**ARBORIST REPORT,  
TREE INVENTORY SUMMARY,  
CONSTRUCTION IMPACT ASSESSMENT  
AND  
TREE PROTECTION PLAN**

**6211 SANTA TERESA BLVD. PROJECT SITE  
(Job # 1042240)  
City of San Jose, California**

***RE: 6211 Santa Theresa Bl. Response to Planning Comments***

Smith DCC: 6211 Santa Teresa Blvd, San Jose, CA Project  
Site Tree #'s 167 & 168

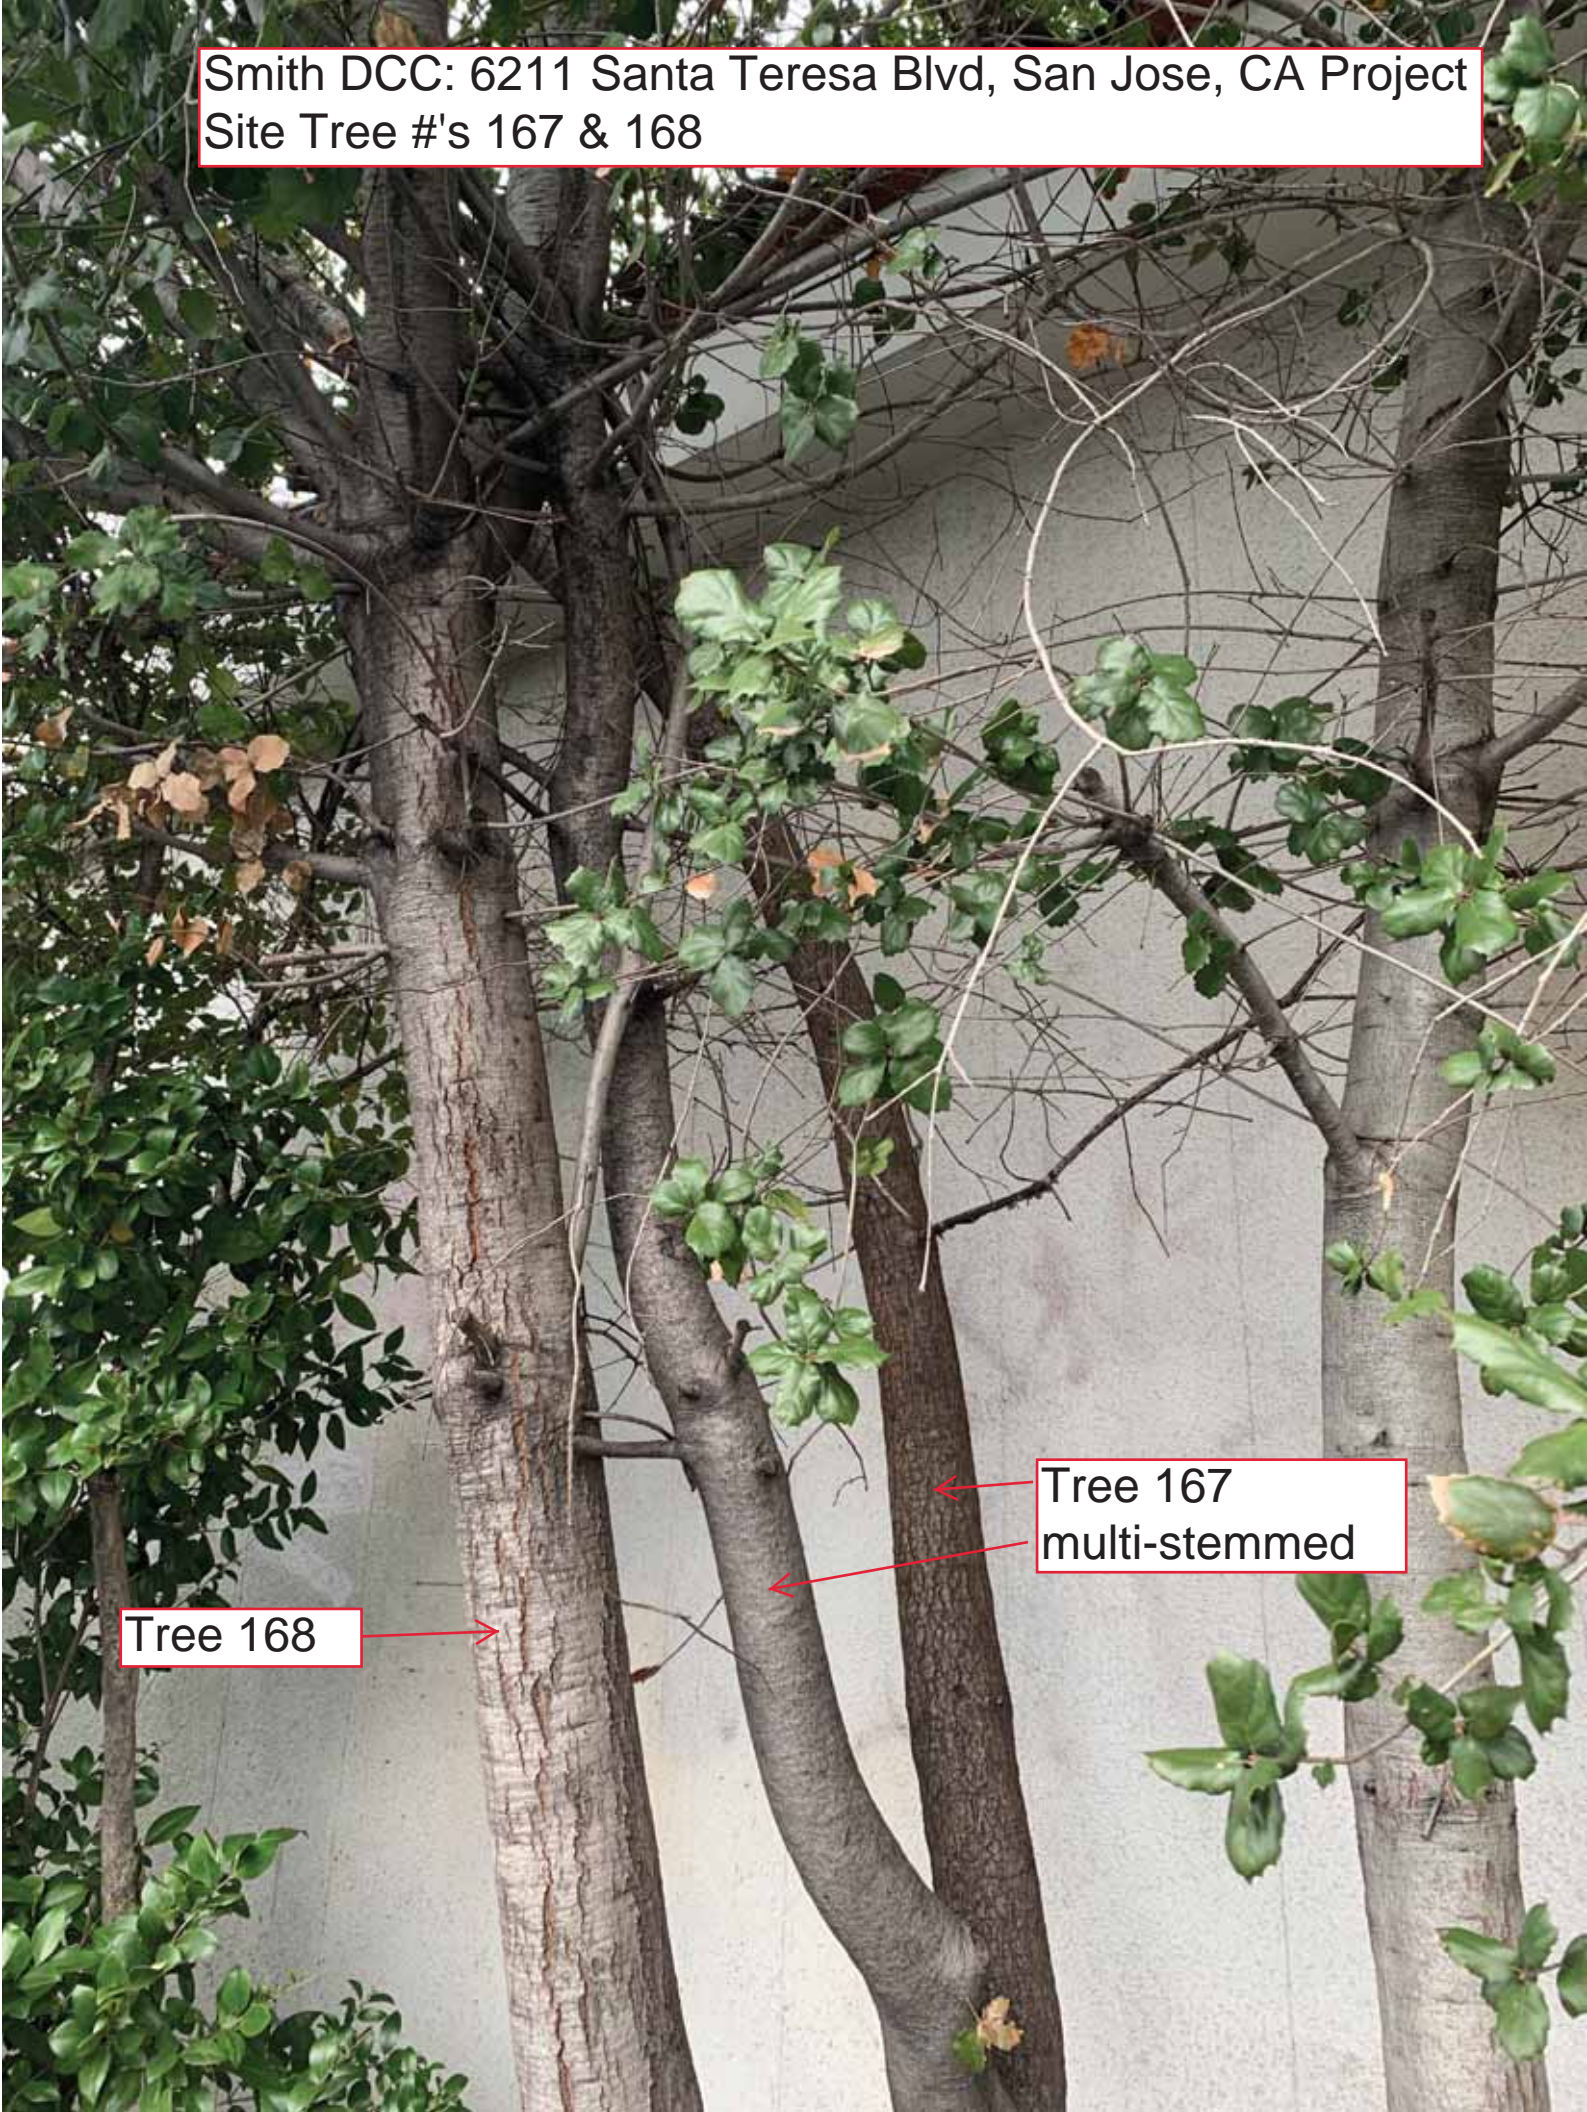
Trees 167 & 168 – These trees have grown in a narrow, raised masonry planter with limited soil volume in close quarters to each other, other trees & the adjacent building (photos attached). The limited soil volume has prevented the trees from growing at a normal rate to a reasonable size. The trees are essentially containerized and this situation causes irregular root growth typically with limited root system development.

The proximity to other trees/plants and the building has caused the trees to lean away from the building, creating an out of balance situation. The trees are also growing through each other with intertwining branches. These trees are actually poor specimens from a structural standpoint and will not tolerate the encroachment that will occur during site demolition and reconstruction. The initial structure rating in the tree inventory was generous and the trees should have been rated lower.

After the existing, surrounding hardscape is removed the stability of the trees will be compromised and there will be an elevated risk of failure due to the disturbance. The existing planter is too small for any type of oak or any large stature tree. Considering the location and extent of proposed activities no protective measures will provide adequate protection for preservation of the trees.

The Palm trees numbered 172, 173 and 174 will be removed per the request from the city public works department. And as discussed above trees 167, 168 and 177 should be removed and replaced with appropriate species in appropriate sized planters.
